SYDNEY PRESTIGE - AUTOHAUS -

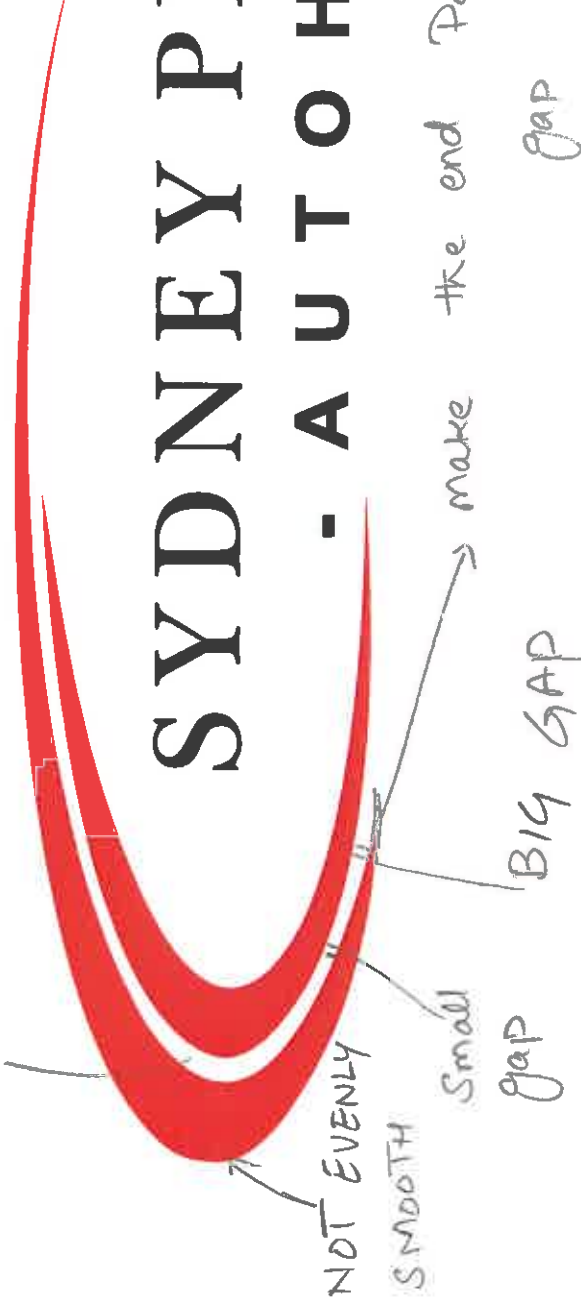
MAKE ALL the Gaps Between Red lines even

- make curves smooth not jagged.

- curving gap between logo ~~should~~ must be consistent and have same gap (including points)
